Product Change Notification - SYST-23IRS0834

ERRATA - dsPIC33CH512MP508 Family Silicon Errata and Data Sheet Clarification

dsPIC33CH512MP508 Family Silicon Errata and Data Sheet Clarification

FIGURE 1-1: I/O RAMP

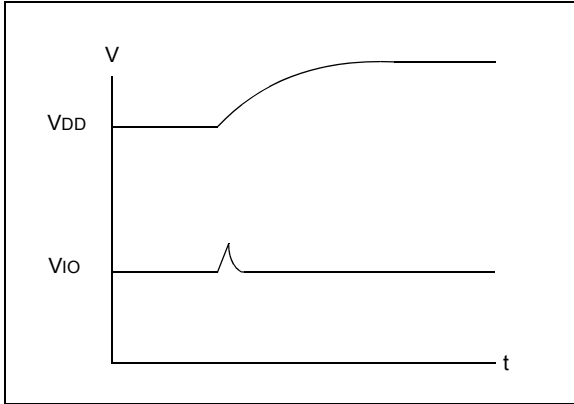
During a fast device power-up, when the VDD ramp is less than 4 mS, the I/O pins may drive up to 100 μ A current for a duration of up to 10 μ S (Figure 1-1).

1. Slow down the VDD ramp time (greater than 4 mS for VDD to ramp 0V to 3.3V).
2. Ensure the circuitry that is connected to the pins can endure this pulse.

Example applications affected may include complementary power switches, where a transient current shoot-through might occur. High-voltage applications with complementary switches should power the high-voltage 200 μ Sec later than powering the dsPIC[®] device to avoid the current shoot-through. This behavior is specific to each device and not affected by aging.
